Access Compliance Report

Public Rights-of-Way

| Intersection ID: 10022932 | Main Street: CEDAR_HILL_DR | Cross Street: N/A | Location: E |
| ADA ID: BFDCD5DFF61F | Ramp Type: Perp | Initial Pass/Fail: Fail | Overall Compliance: No |

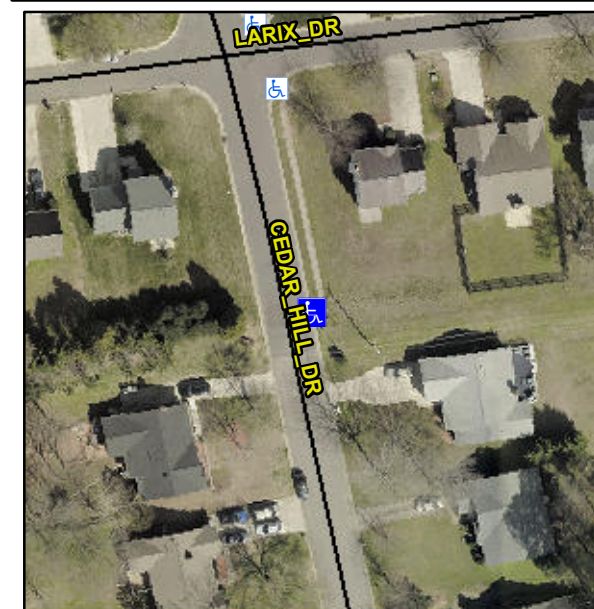
Not Found, R304.2.2, R304.5.3

| Compliance | Description | Data | Compliance | Description | Data |
|------------|-----------------------|------|------------|-----------------------------|------|
| N/A | Ramp Length (in) | 48.0 | No | Ramp Slope (%) | 9.0 |
| Yes | Ramp Width (in) | 48.0 | No | Ramp XSlope (%) | 2.6 |

Remove & Replace Entire Ramp.
